APPENDIX III
TO THERMAL SCIENCE, INC.'S RESPONSE TO THE
UNITED STATES NUCLEAR REGULATORY COMMISSION'S
LETTER DATED 10 SEPTEMBER 1991

TSI Technical Note 20684-EIH

THERMO-LAG 330 Fire Barrier System Installation Procedures Manual

Prepared For Bechtel Power Corporation, For Georgia Power Company, Edwin

FIGURE 1

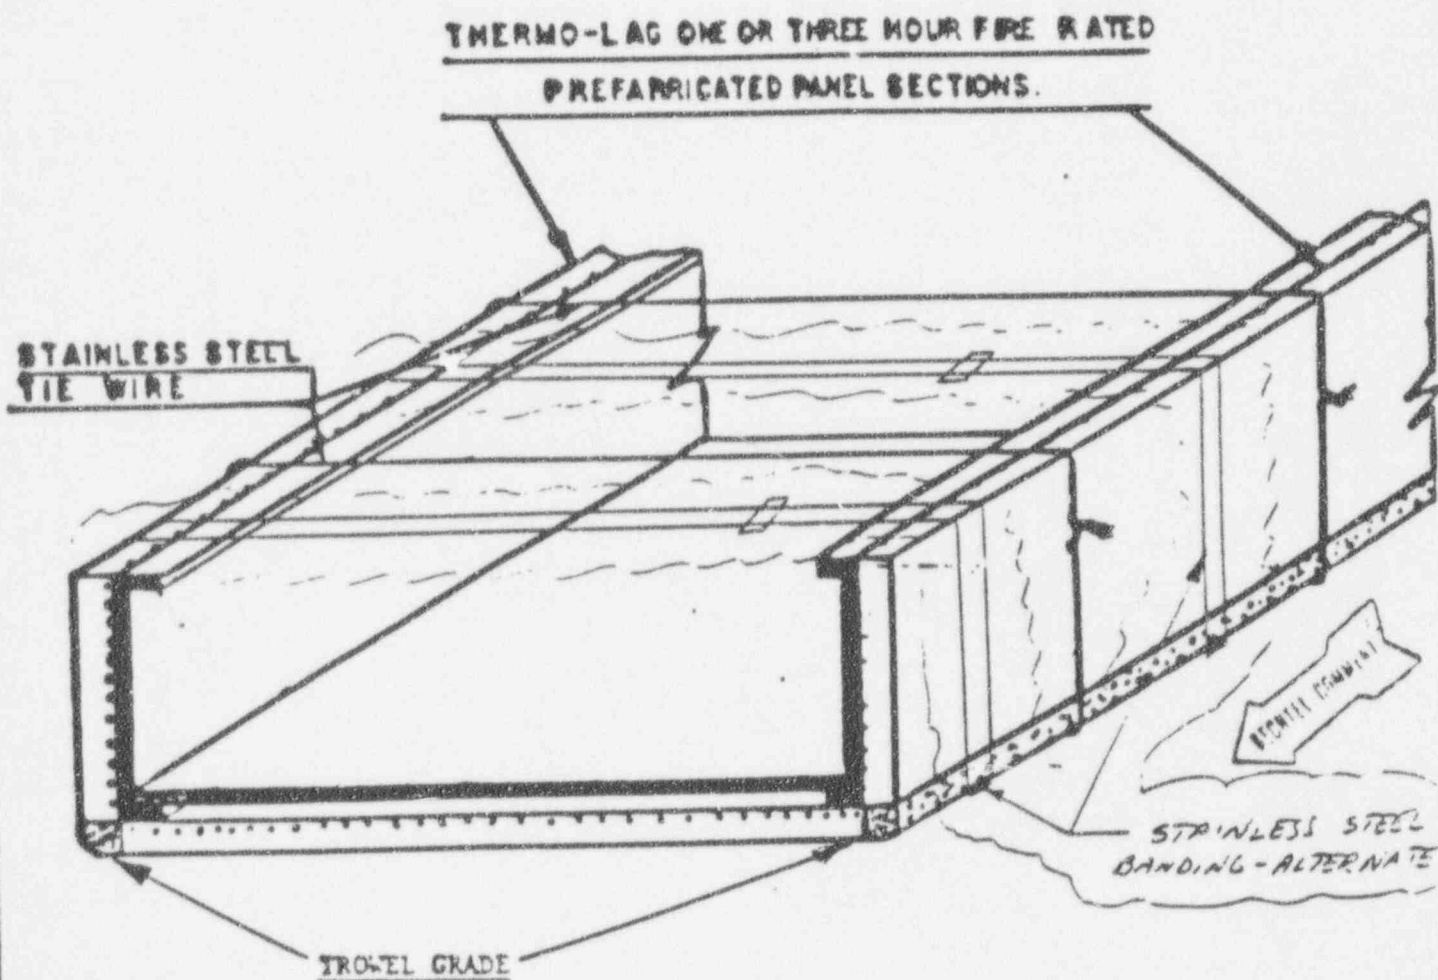
- e. Attach the flat top section to the installed bottom section using stainless steel tie wires or banding as shown in Figure 2. The maximum spacing between the tie wires or banding shall not exceed 12 inches. Distance from the end of panel should be specified.

FIGURE 3

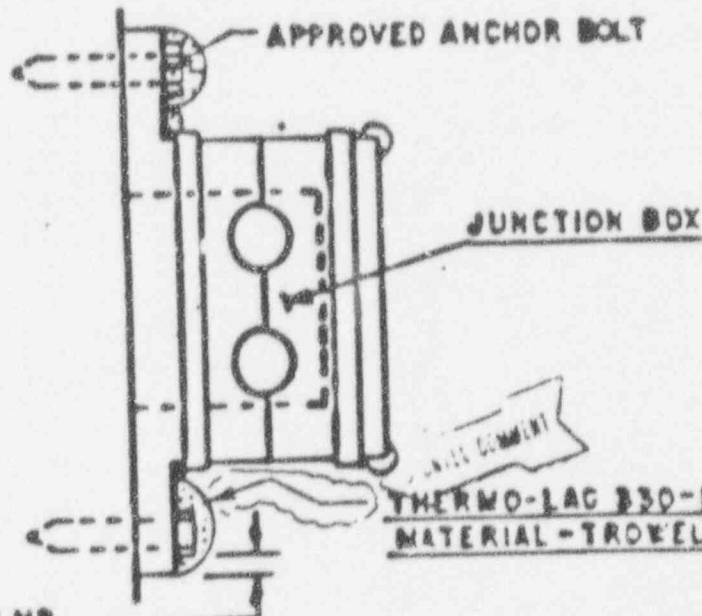
- d. Mount the *BECHTEL COMMENT* formed section *ENCLOSURE* on the wall or ceiling using approved concrete fasteners. The concrete fasteners shall be spaced at a maximum distance of 12 inches with at least two concrete fasteners being used per flange. The concrete fasteners shall be site approved anchors of 1/4 inch minimum diameter *BECHTEL COMMENT* installed per standard site procedure. *and 3 1/2" min. in length* *BECHTEL COMMENT*

- e. Cut two sections from a one hour or three hour fire rated Prefabricated Panel for the side panels of the fire barrier enclosure. Cut holes for conduit penetrations in the top, front and bottom panels as required and then cut the panel or panels into two pieces to facilitate installation around the conduit. Mount the side panels on the installed top, front and bottom section enclosure using stainless steel banding as shown in Figure 3. *BECHTEL COMMENT*

FIGURE 4

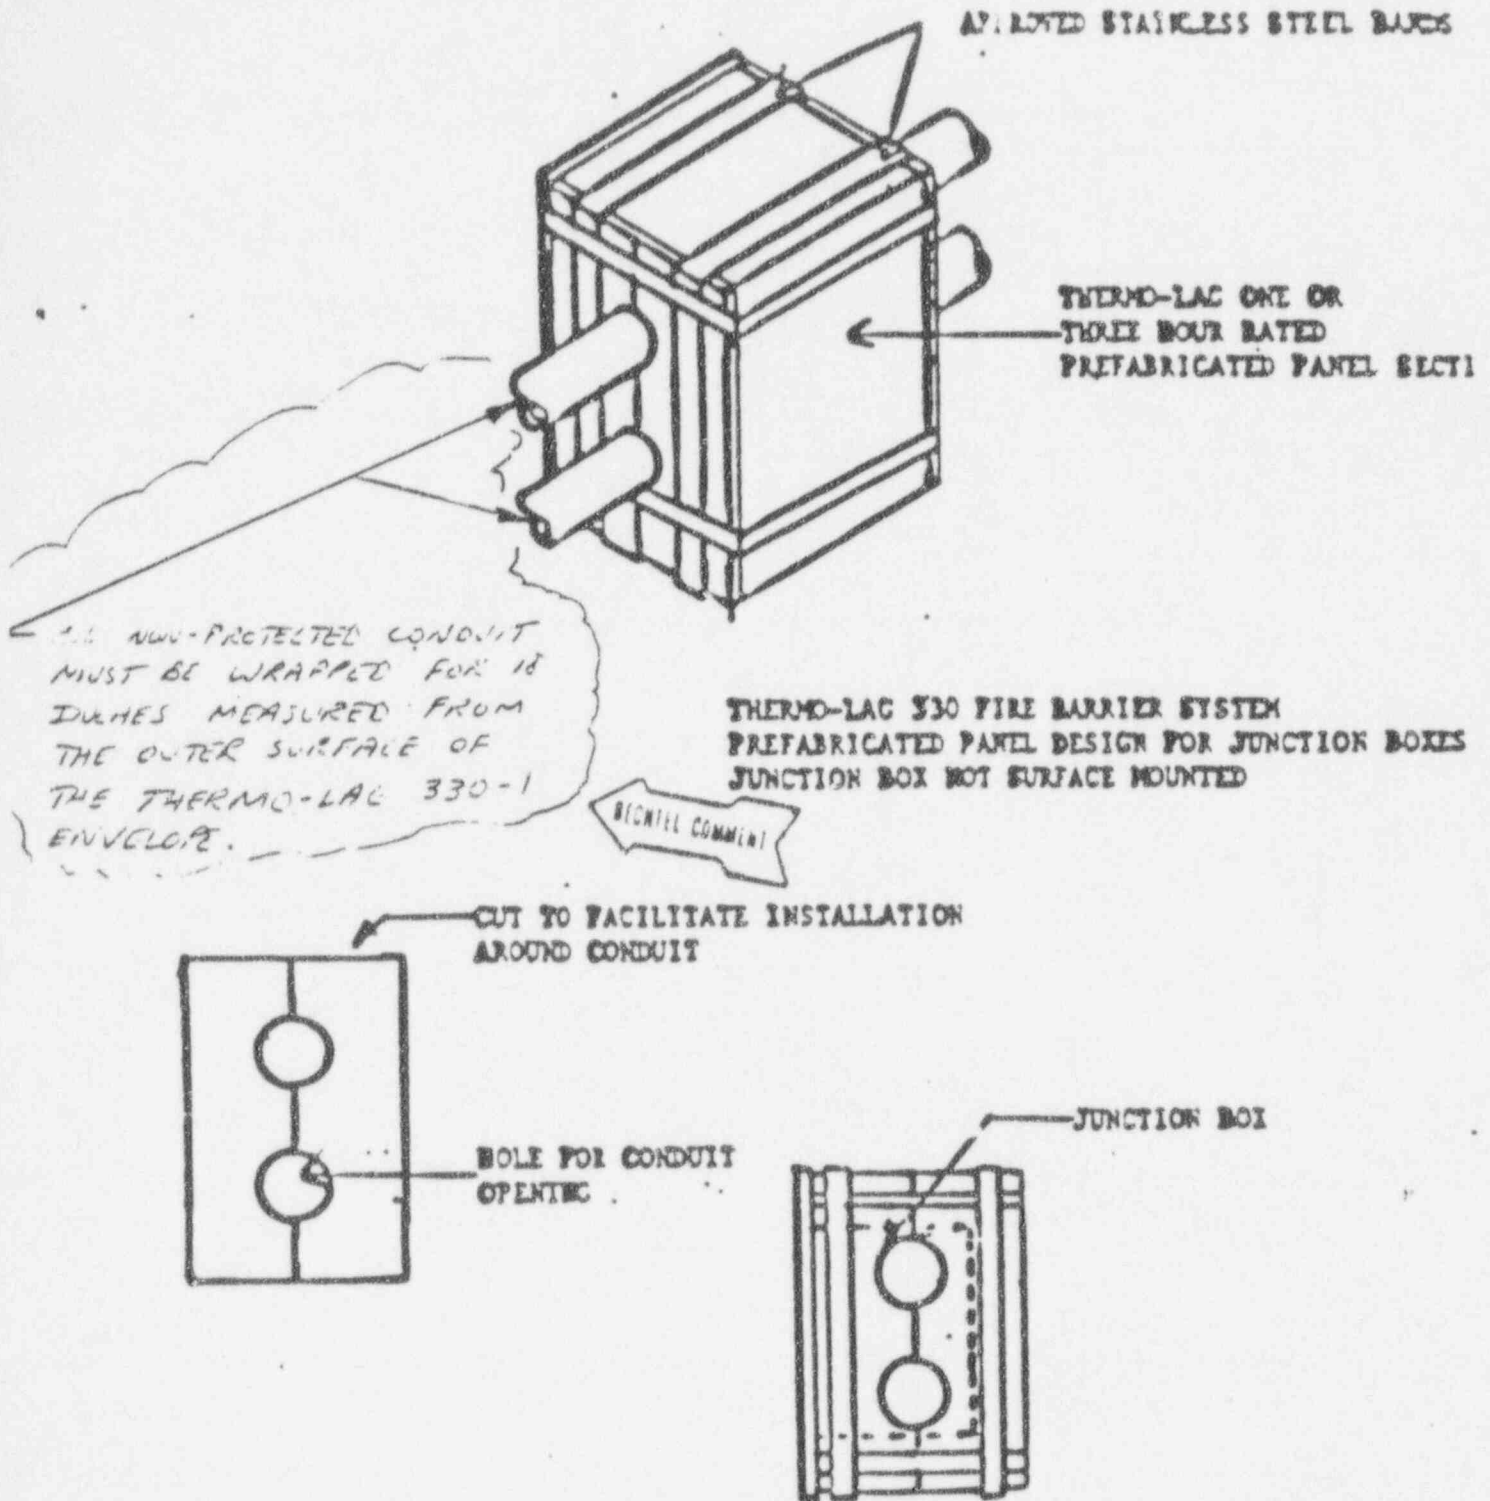
- m. Mount the two fire barrier sections on the junction box and fasten the two sections together using stainless steel banding *AS SHOWN IN FIGURE 4.*

FIGURE 7

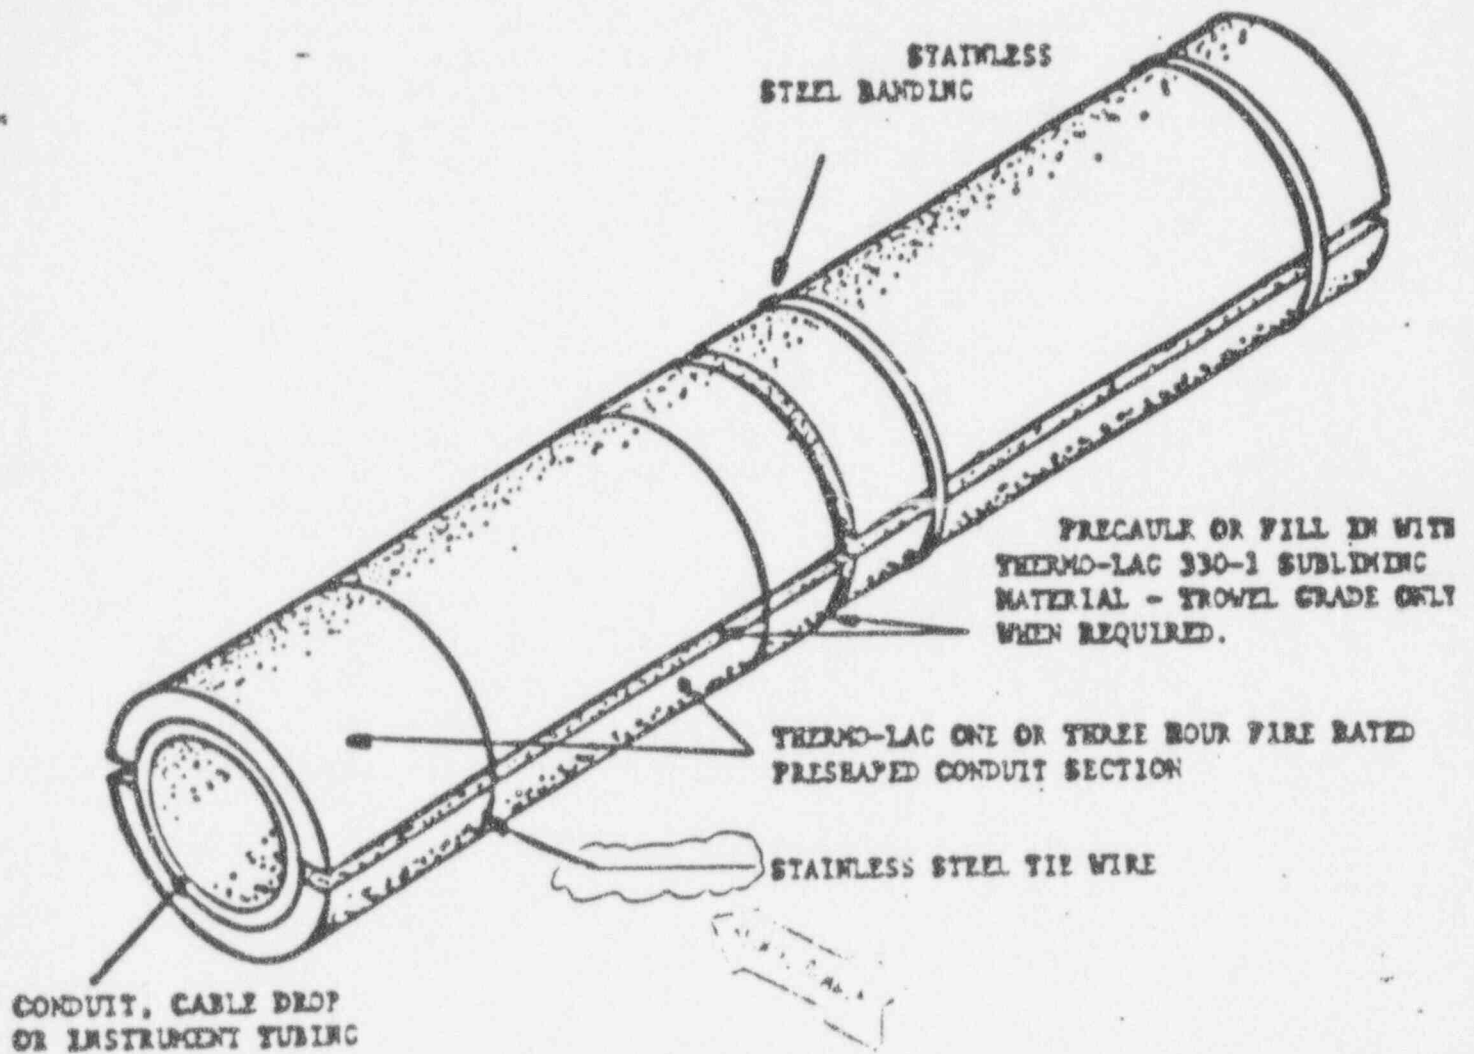
- b. Mount the coated section and one other one or three hour fire rated section on the conduit, cable drop or instrument tube with the edges flush with each other to form a cylindrical section around the conduit, cable drop or instrument tube. Fasten the two sections together using stainless steel tie wires or banding installed at 12 inch intervals, maximum, as shown in Figure 7. Distance from the end of preshaped section should be specified.

FIGURE 6

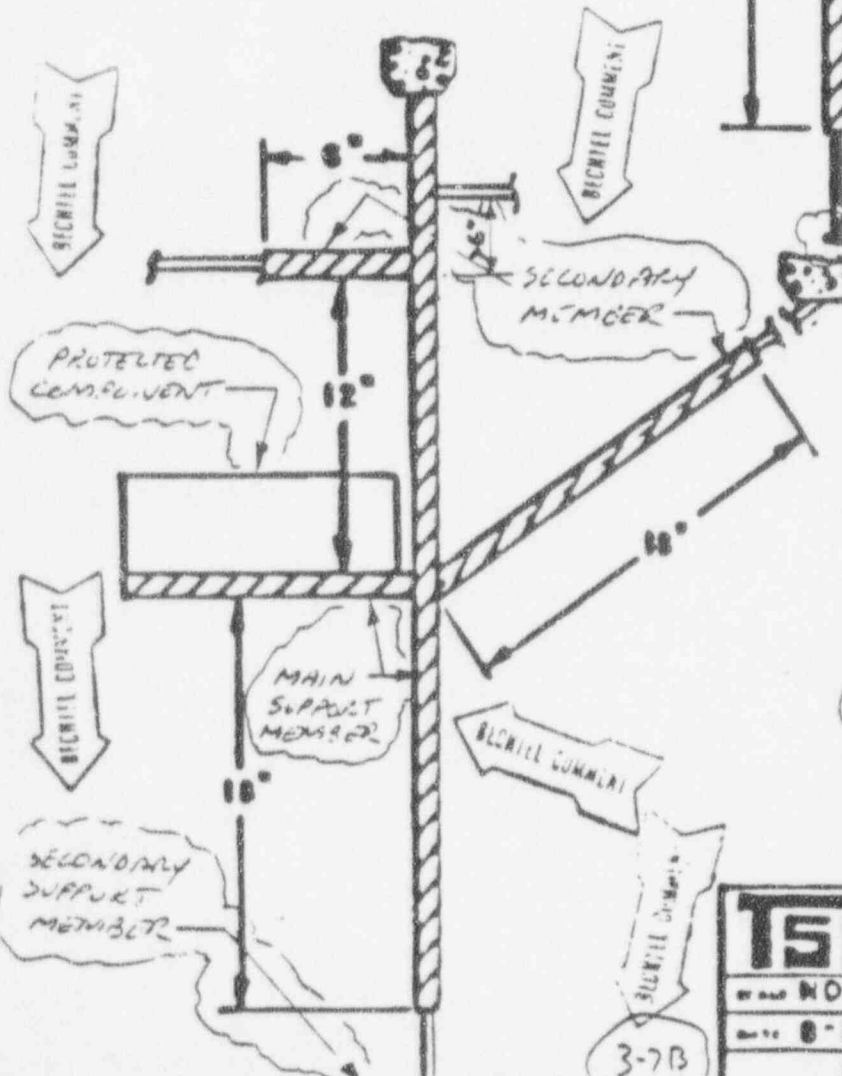
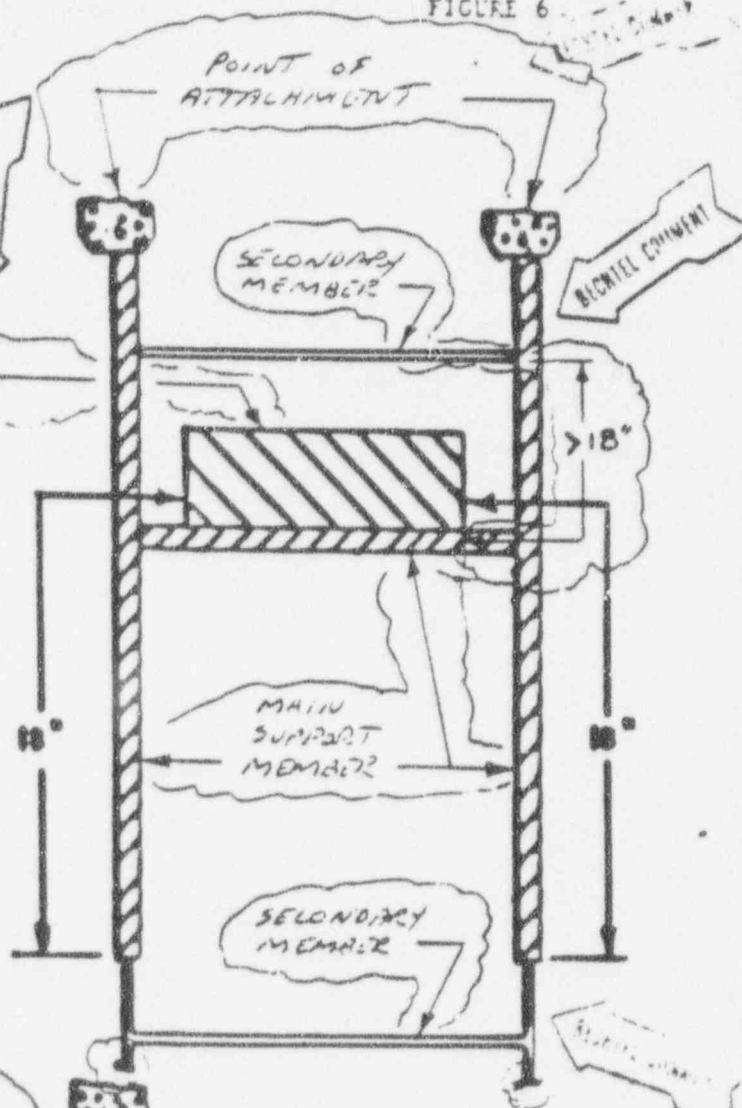
Give this sketch to the section on structural support. Revise figure number as necessary.

FIGURE 12

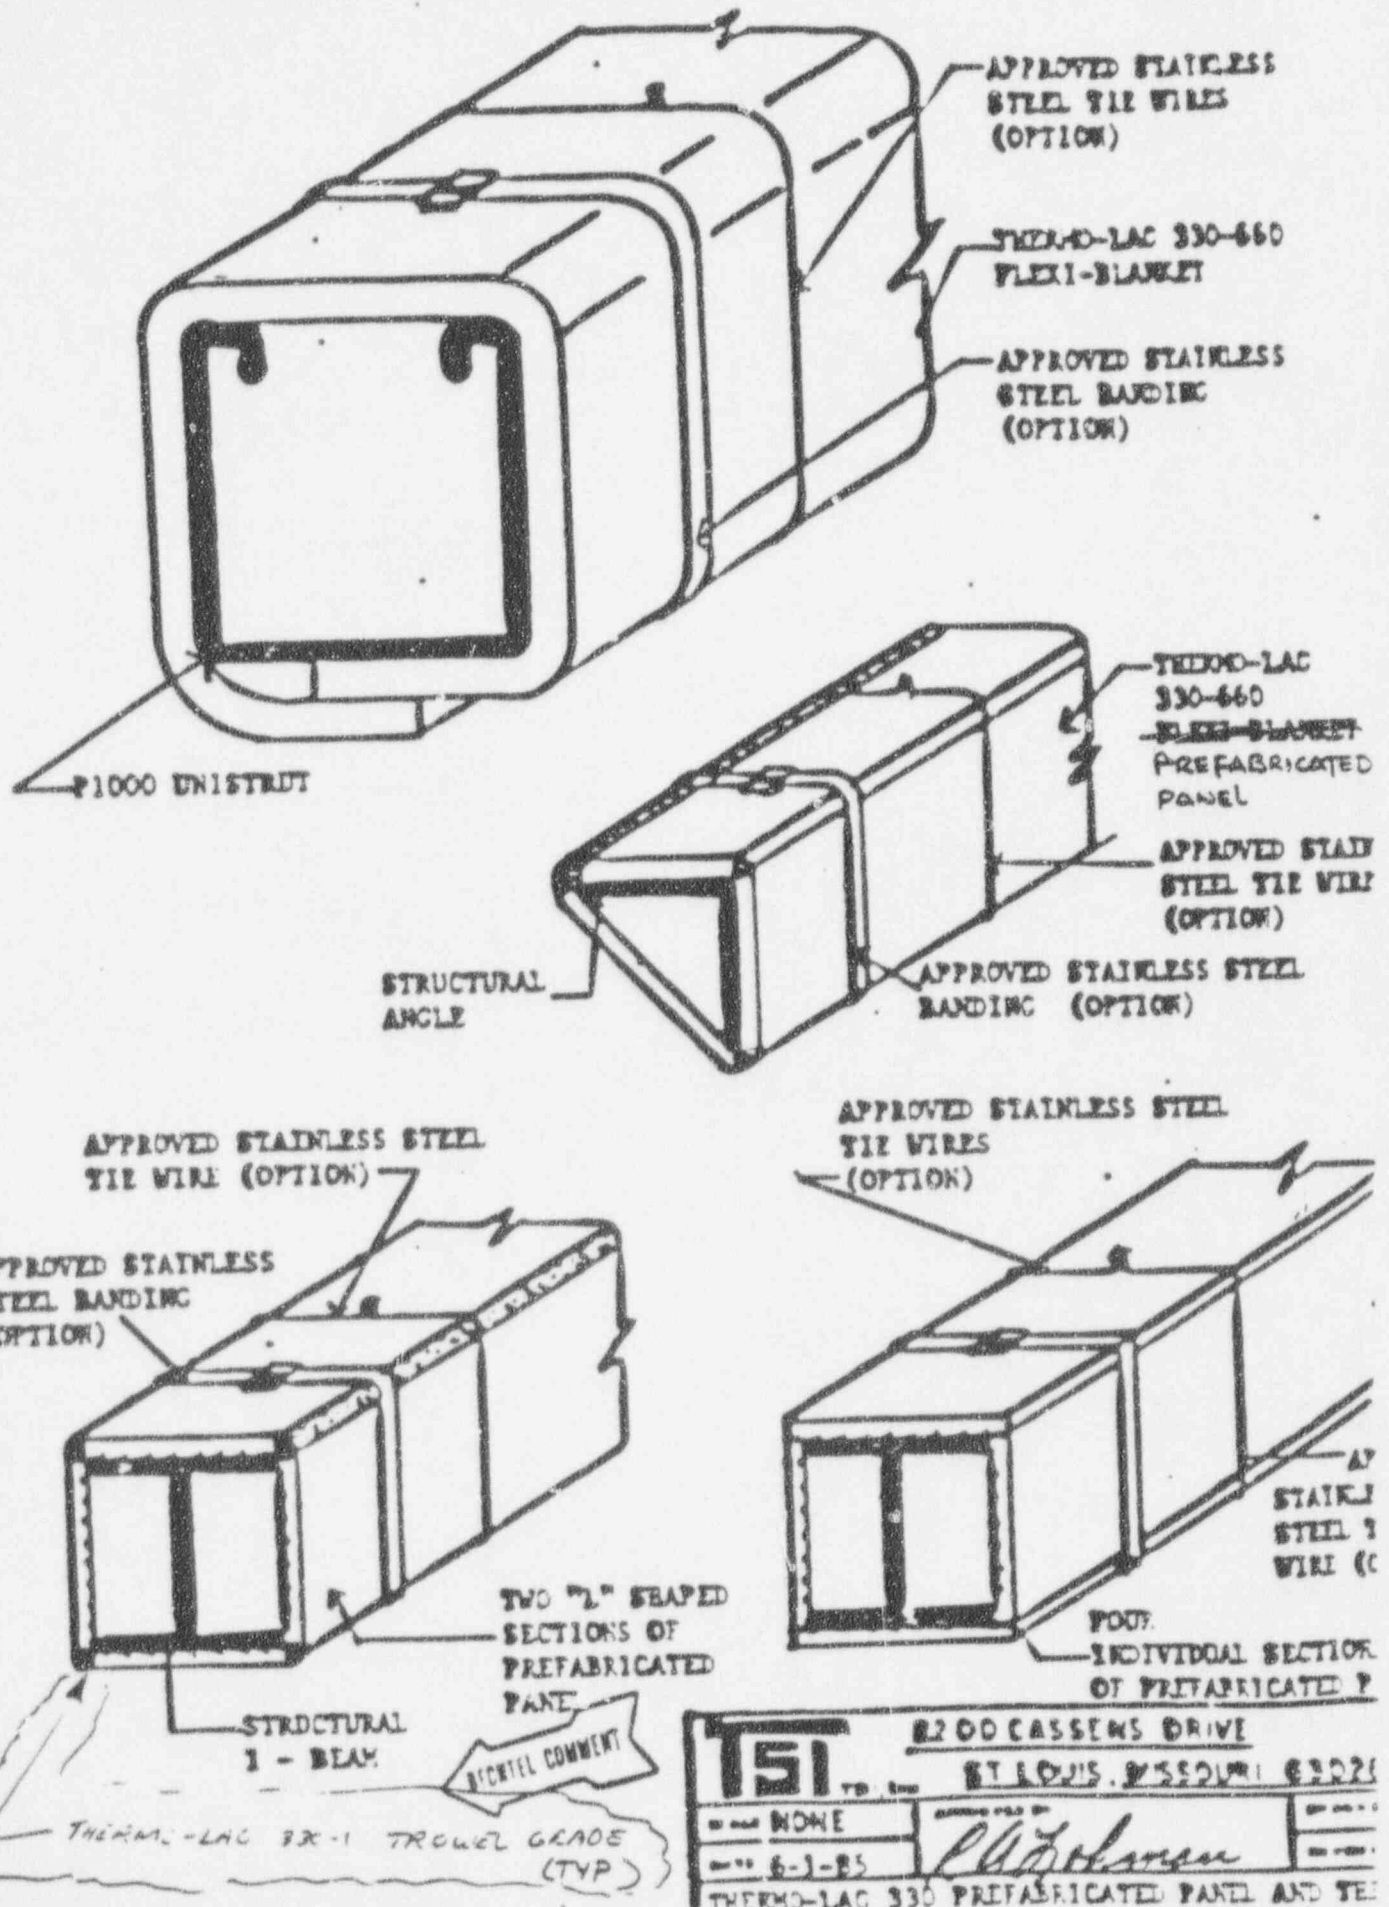
2.4.3 ~~2.1.3~~ Mount the two "L" shaped sections on the structural support or hanger, using 18 ga. minimum stainless steel tie wires or 0.5" x 0.020" minimum stainless steel banding material as shown in Figure 12.
